Valley of the Winds Wind Farm

Amendment Report

Project name **Valley of the Winds Wind Farm**
Project no. **318001172**
Recipient **ACEN Renewables Australia Pty Ltd**
Document type **Amendment Report**
Version **V2**
Date **27/10/2023**
Prepared by **Clare Butterfield / Belinda Sinclair / Jon Williamson**
Checked by **Belinda Sinclair**
Approved by **Belinda Sinclair**
Description **Amendment Report for the Valley of the Winds Wind Farm project.**

Figure 3-1 | Amended project overview

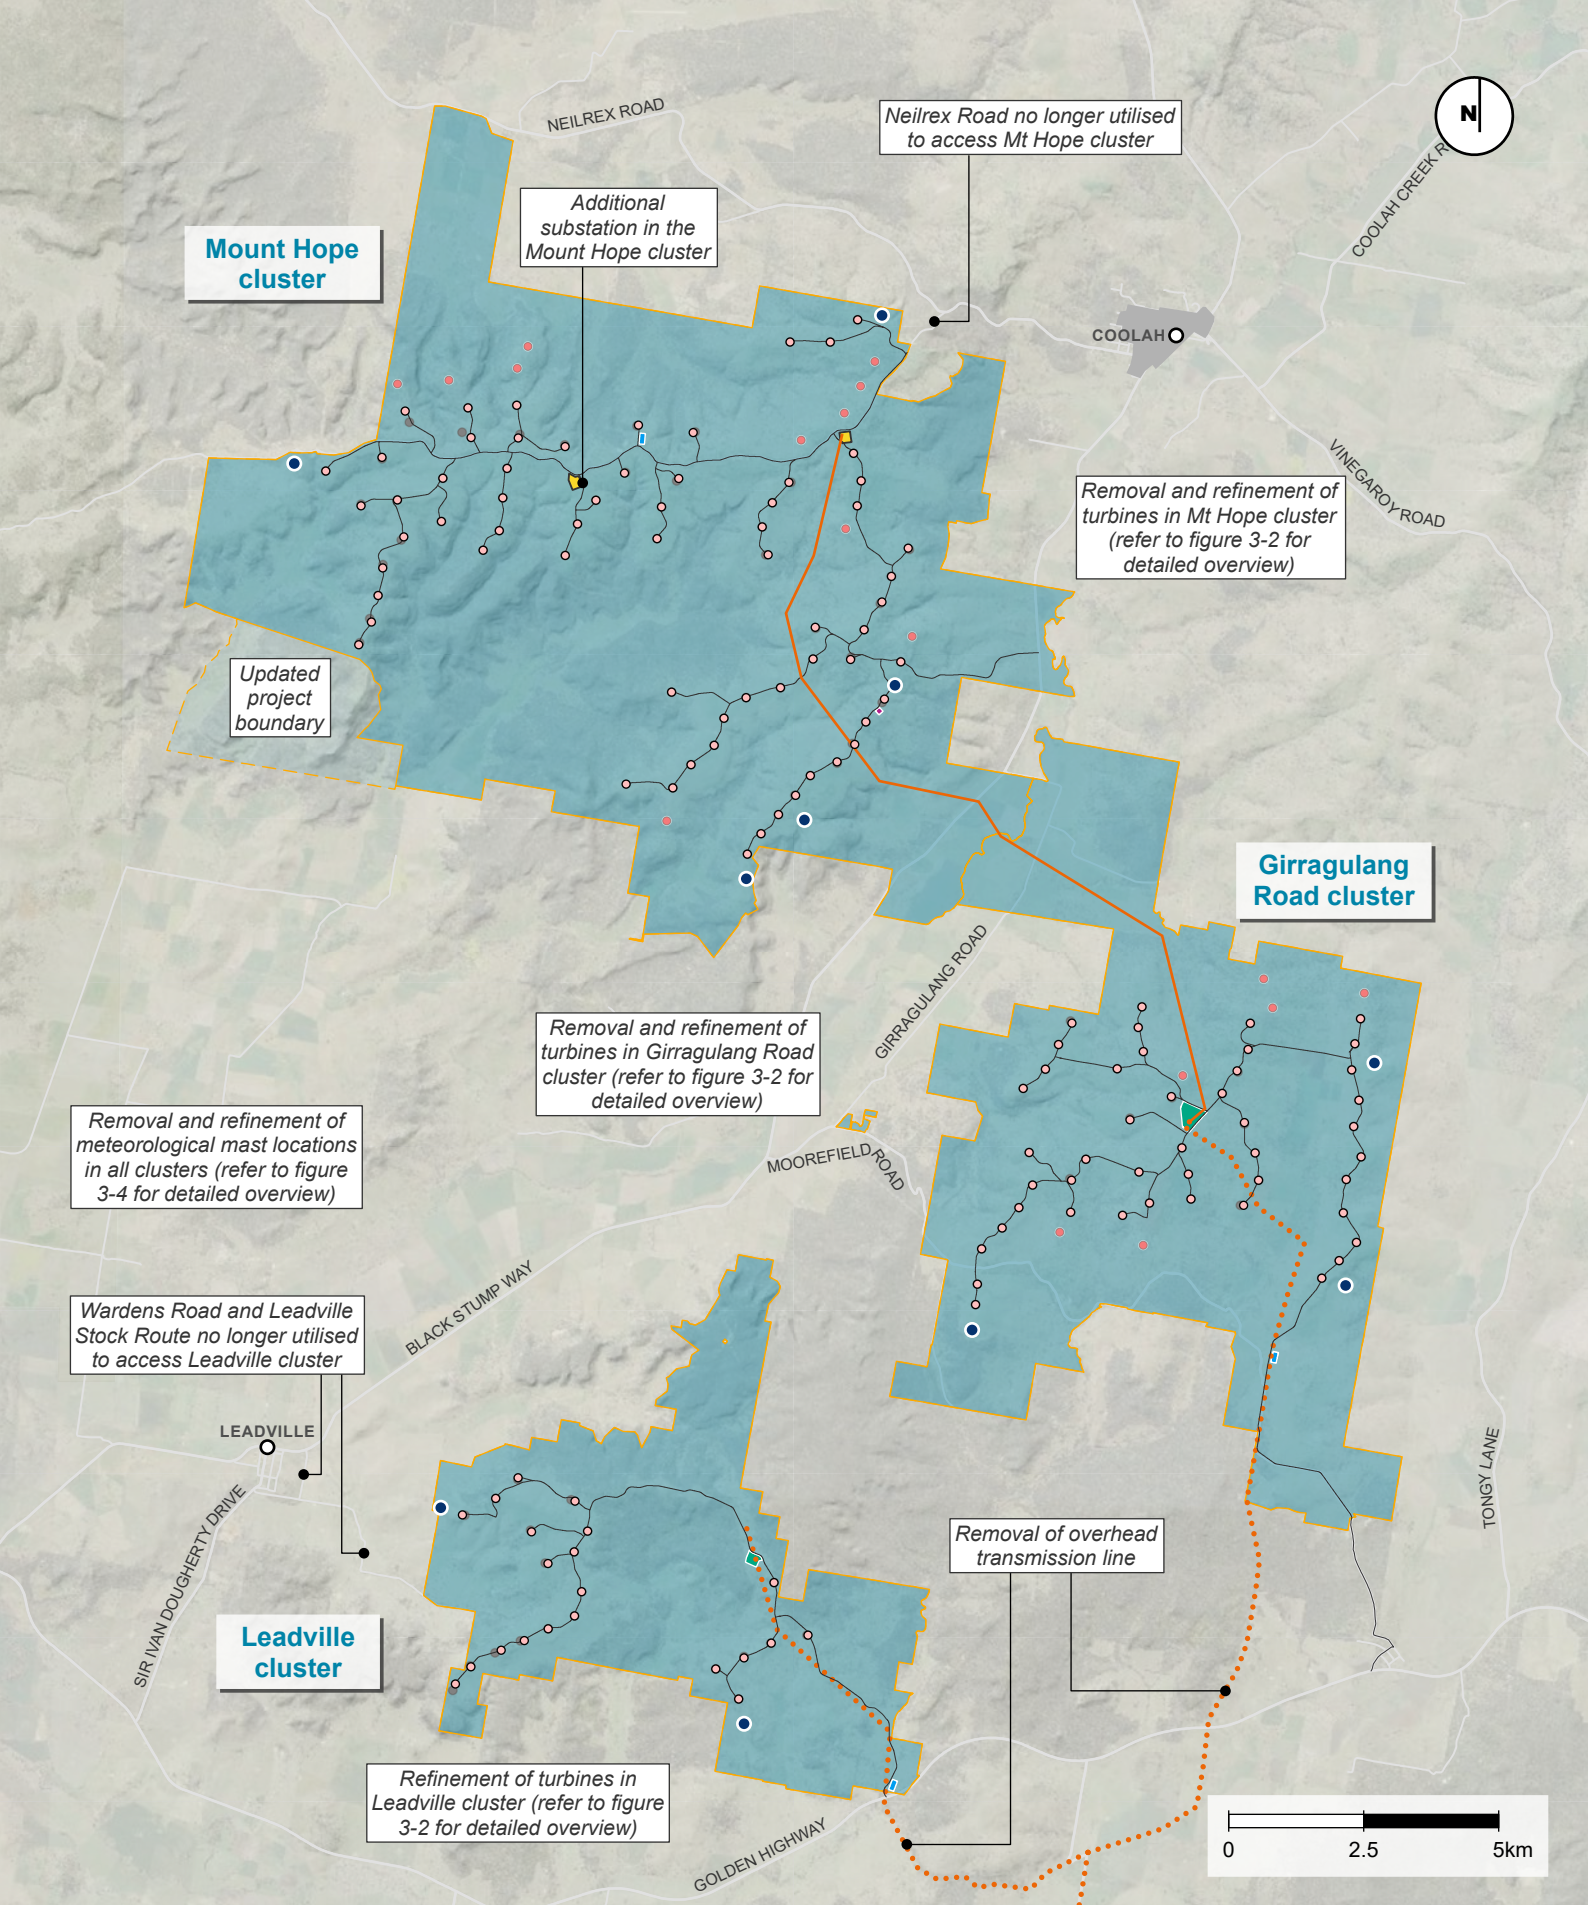
The amended project layout is discussed further in **Chapter 3** and shown in **Figure 3-1**.

An overview of the amended project compared to the project included in the original development application is provided in **Table 3-1** and an indicative layout of the amended project is provided in **Figure 3-1**.

Figure 3-2 | Amendments to the turbine layout

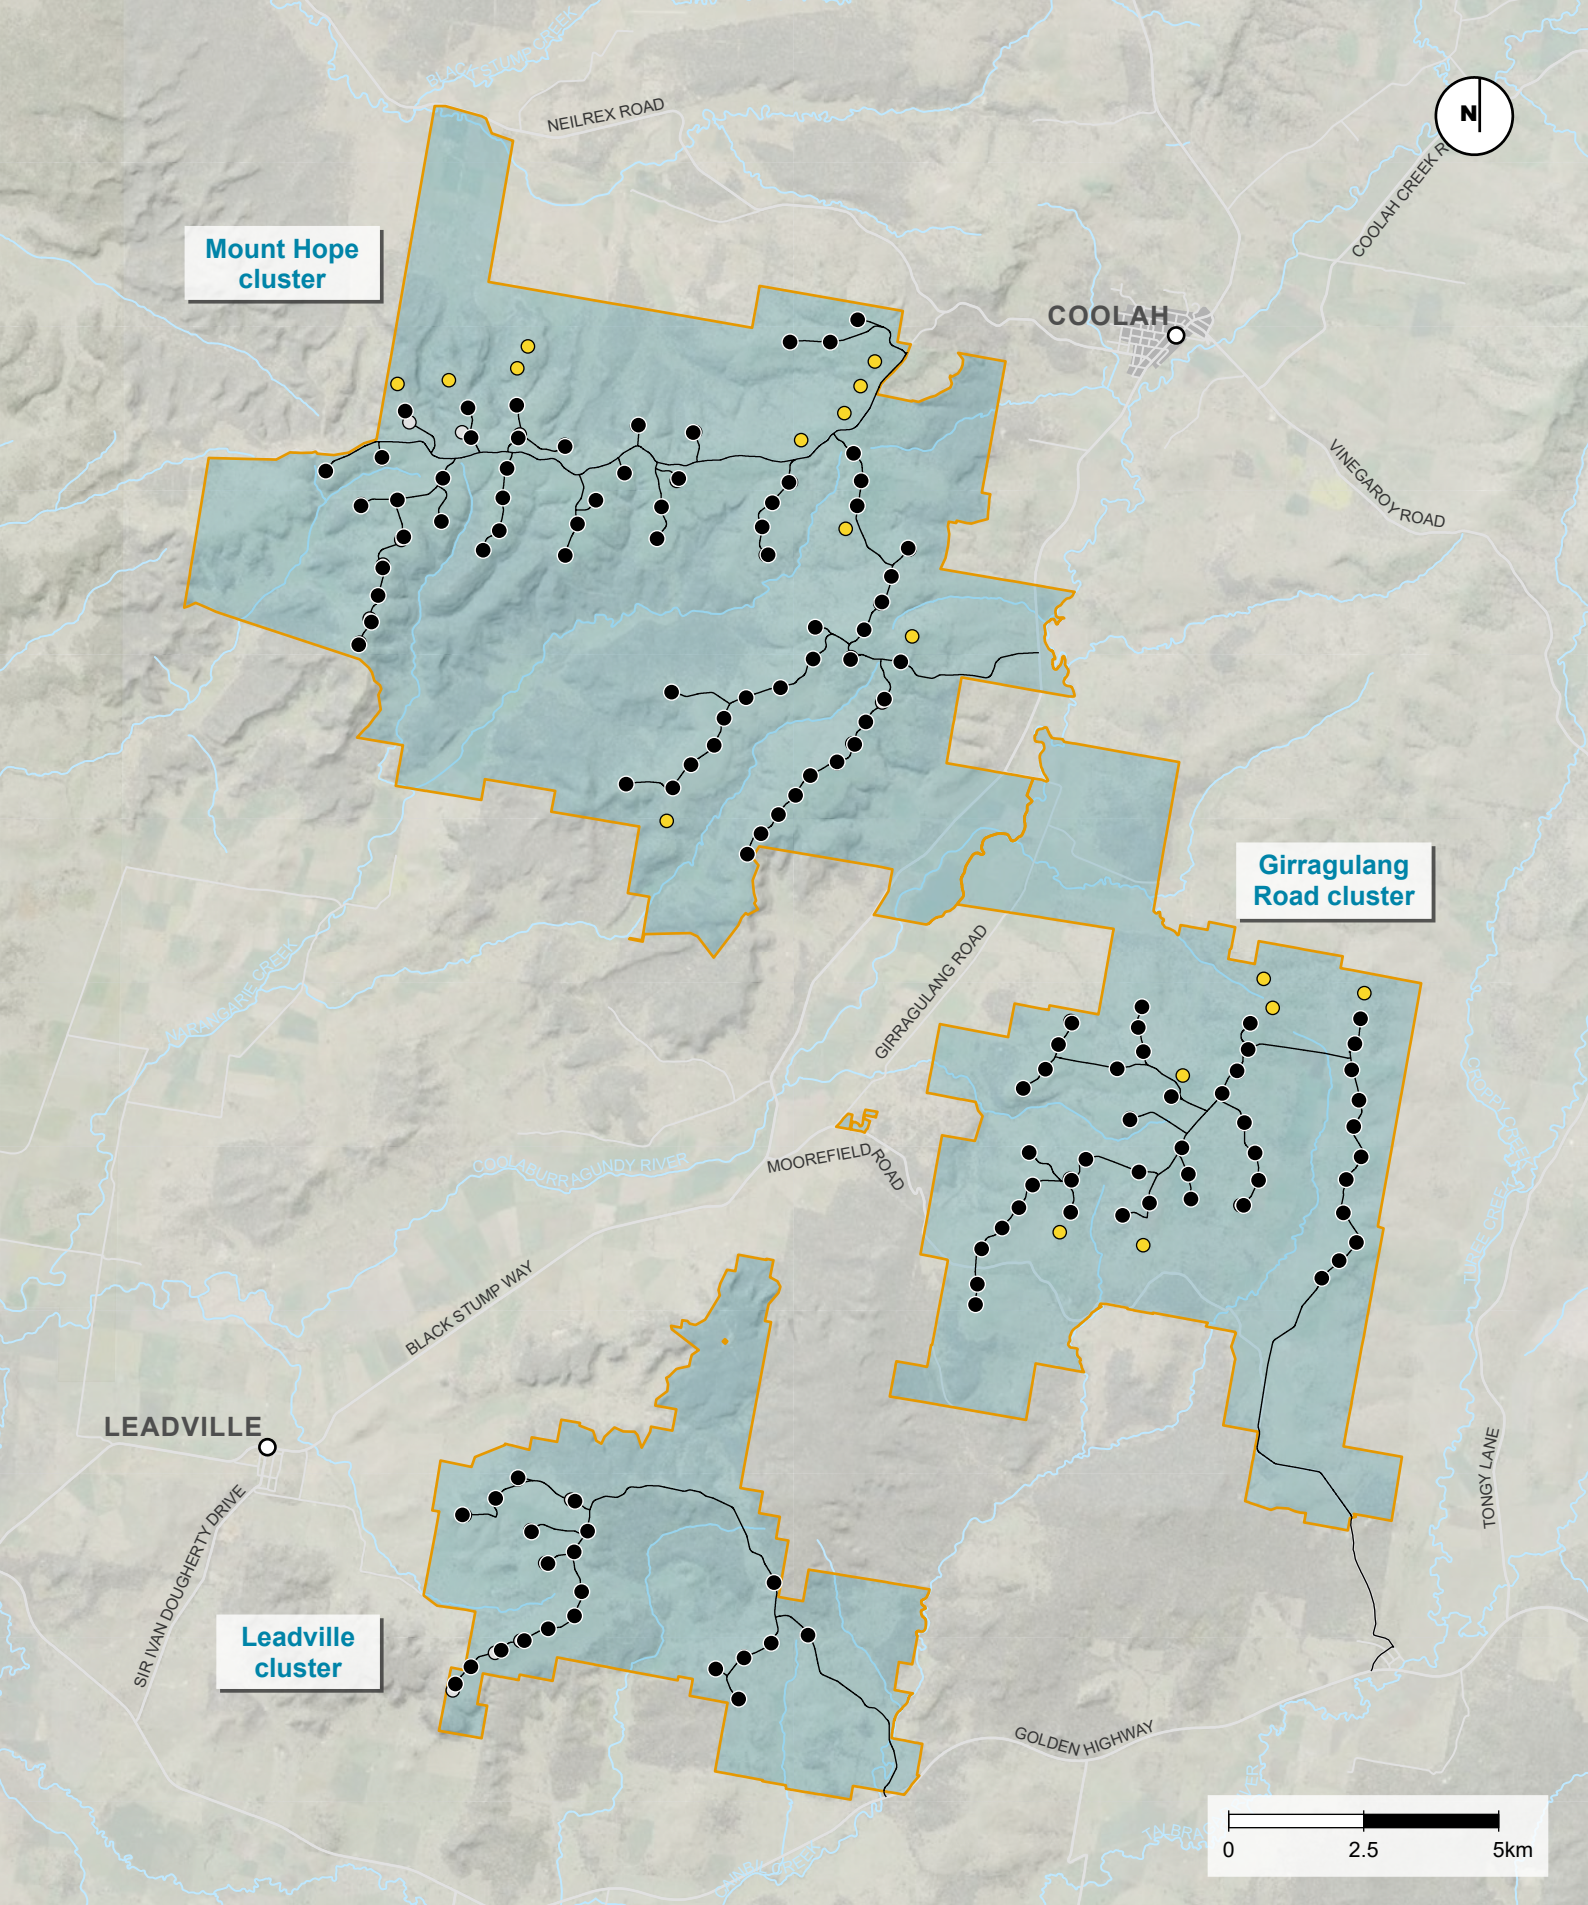
ACEN proposes to remove 17 turbines from wind farm layout to reduce amenity impacts for nearby dwellings and biodiversity impacts.

The amended turbine layout is shown in **Figure 3-2**, and a comparison of the disturbance footprint included in the original development application, against the disturbance footprint for the amended project is provided in **Figure 3-3**.

Figure 3-4 | Amendments to meteorological mast locations

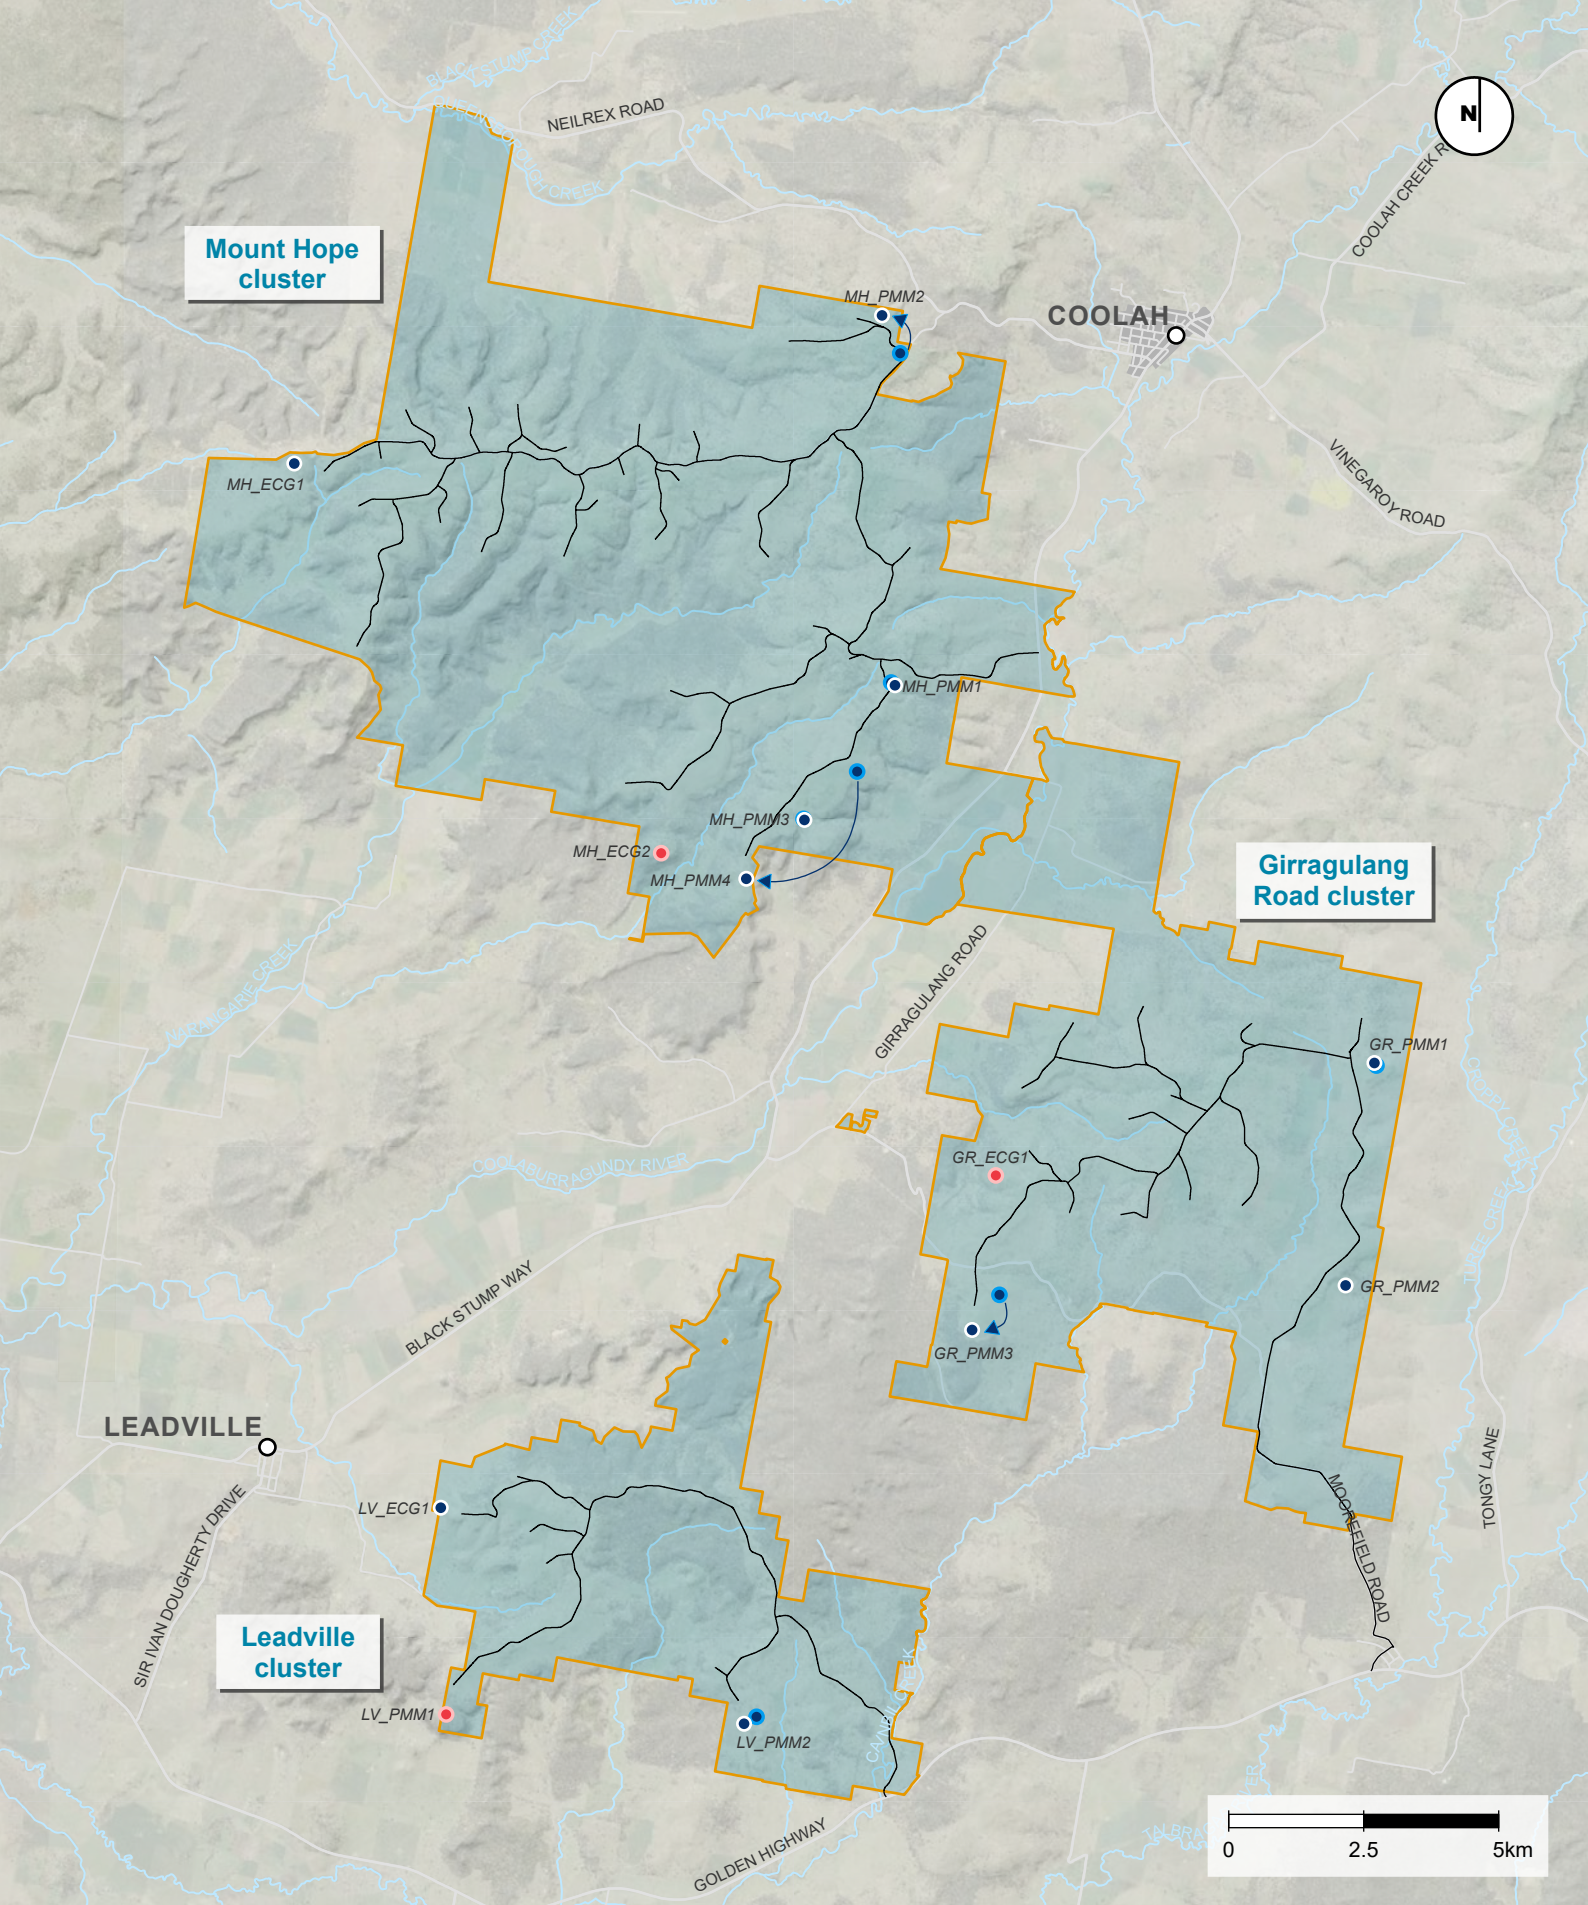
As part of the amended wind farm layout, ACEN have refined the proposed locations of the permanent met masts to further avoid and minimise potential impacts to biodiversity. Three permanent met masts have also been removed as part of this refinement and the amended locations are shown in **Figure 3-4**.
